Evaluation of Crack Growth Rates for Alloy 690/52/152 and Alloy 600/82/182/132

NRC Meeting
February 15, 2018

The objective of this meeting is to present the EPRI MRP report on Alloy 690/52/152 PWSCC crack growth rates and provide clarifications and address comments on the report.

Weld Interface and Dilution Zone Testing

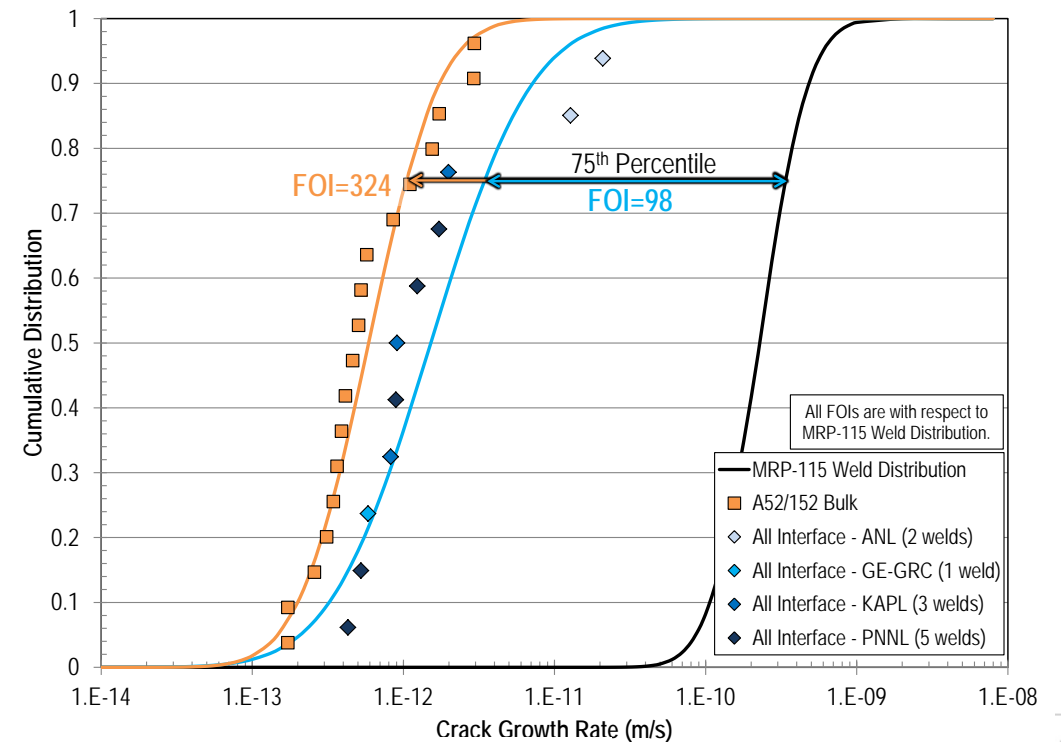
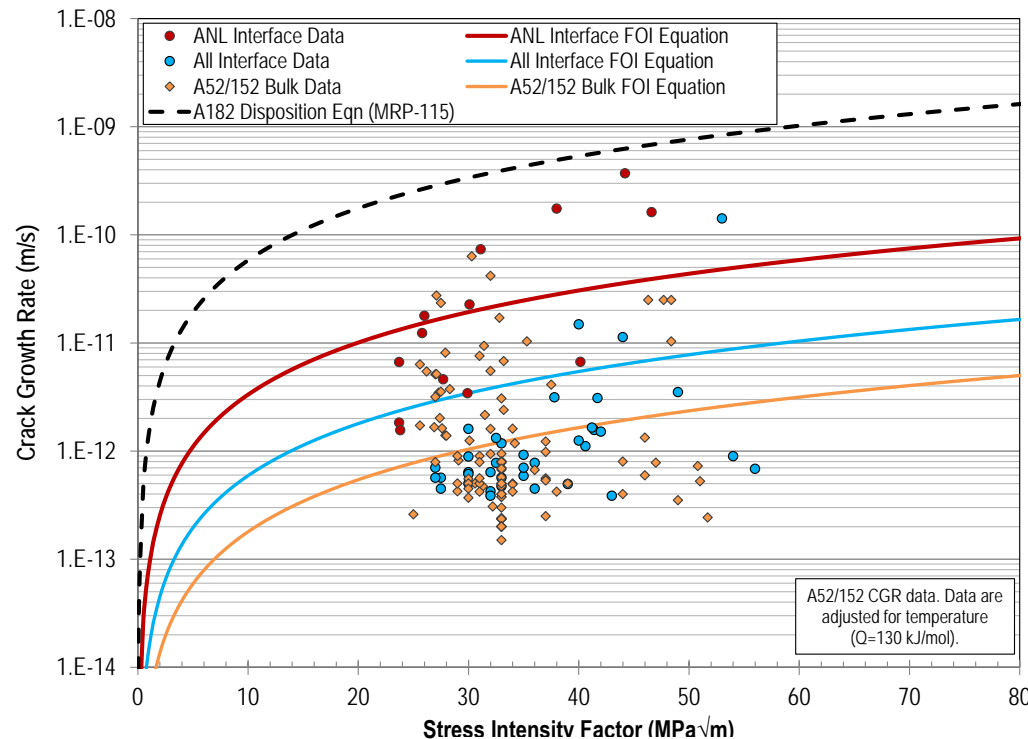
- Susceptibility of dilution zone (DZ) is likely affected by type of interface and welding parameters
- Microstructural features, such as localized high strain boundaries, could play an important role, but they are not well understood

- Addressed in Section 4.7.4 and Appendix G.7
- The Expert Panel decided that there were insufficient data available at the time to predict CGRs specific to Alloy 52/152 dilution zones/weld interfaces due to the wide variety of interface types and limited data for each (50 total points, 6 interface types)
- Instead, these sections describe the chromium dilution levels expected (based on mockups) and include data from the Environmental Degradation Conference 2017 (Toloczko) that show that there is generally no through-wall leak path through high strain boundaries
